WELL API NO. <b>30-025-41615</b>
5. Indicate Type of Lease STATE <input checked="" type="checkbox"/> FEE <input type="checkbox"/>
6. State Oil & Gas Lease No.
7. Lease Name or Unit Agreement Name <b>Dragon 36 State SWD</b>
8. Well Number <b>11</b>
9. OGRID Number <b>7377</b>
10. Pool name or Wildcat <b>SWD; Delaware</b>
11. Elevation (Show whether DR, RKB, RT, GR, etc.) <b>3521' GR</b>

EOG Resources, Inc. proposes to change the approved casing design from a 3 string to a 2 string for this well as follows:

Dragon 36 State SWD #11  
Lea County, New Mexico  
Revised  
Proposed Wellbore

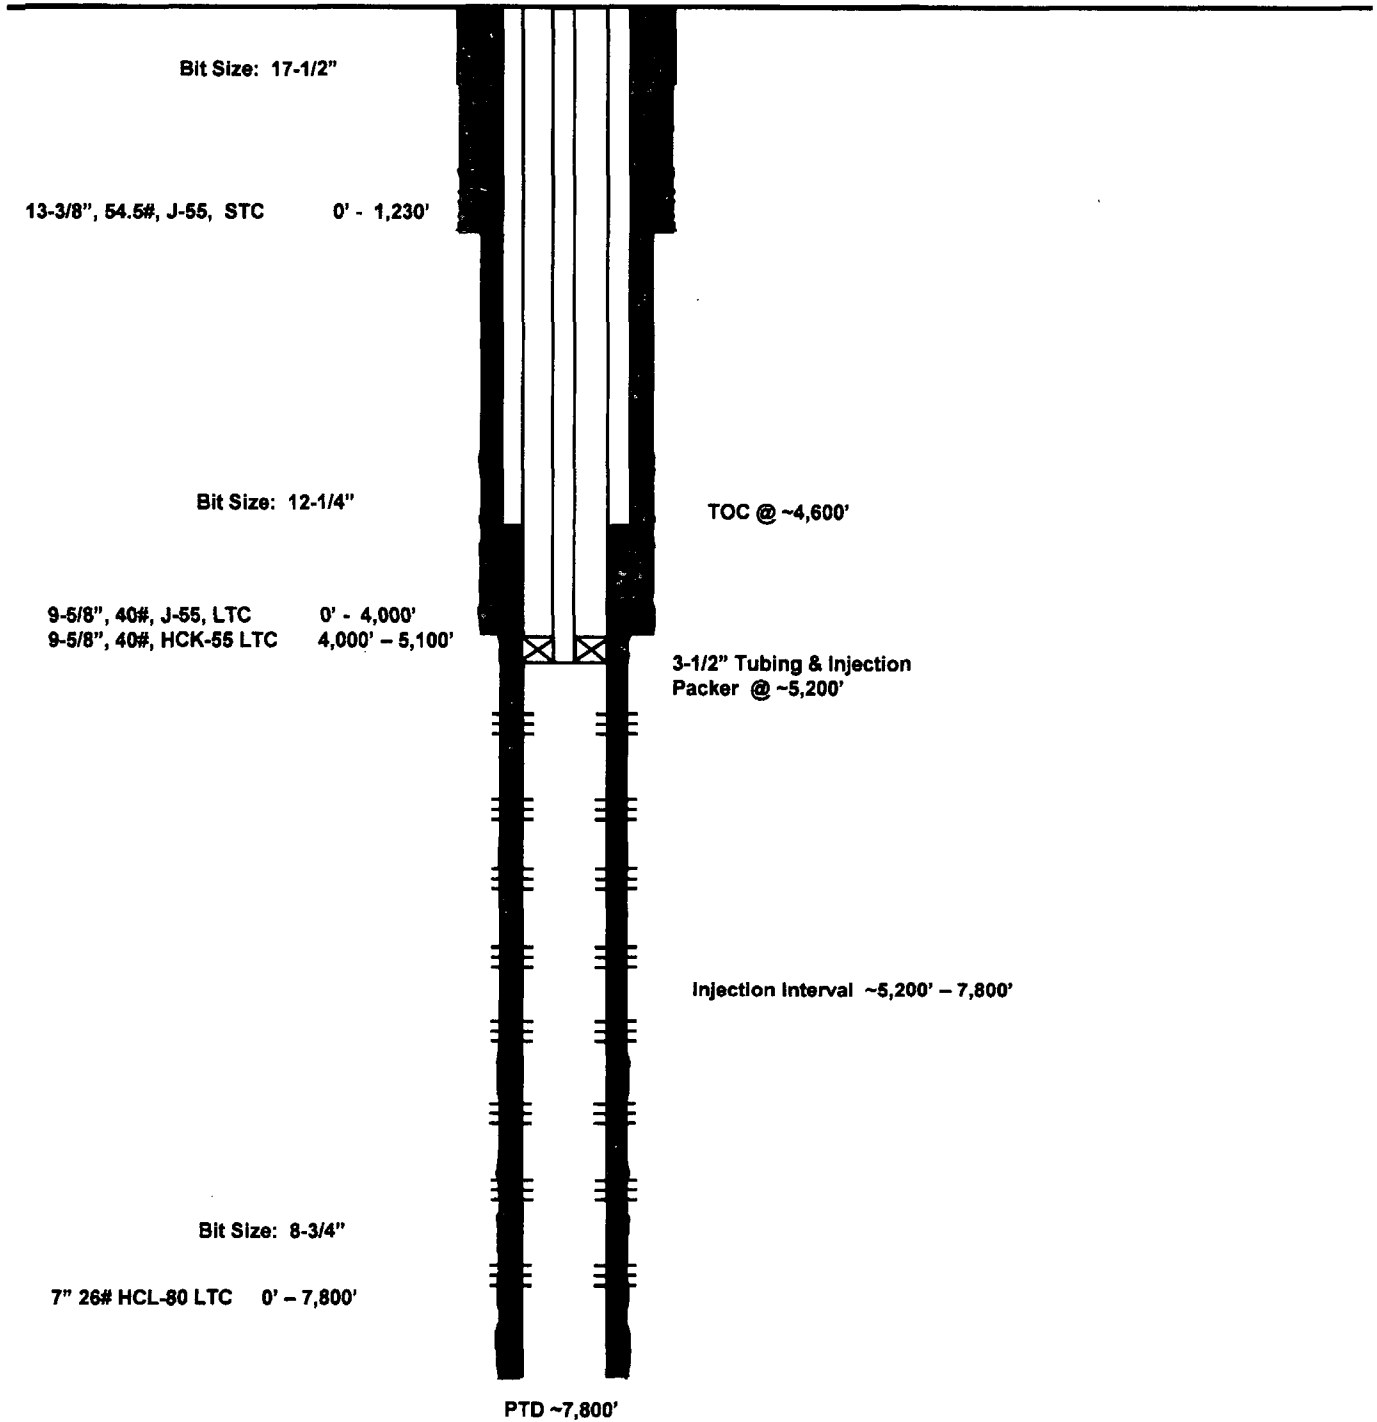
1. Drill 12-1/4" hole size to 1230' using FW mud.
2. Run and cement 9-5/8", 40#, J55 STC casing and cement to surface.
3. Drill 8-3/4" hole to TD at 7800' using Oil Base mud.
4. Run 7", 26# HCL-80 LTC casing w/ DV tool w/ ECP at 5100'.
5. Cement via 2 stage to surface.
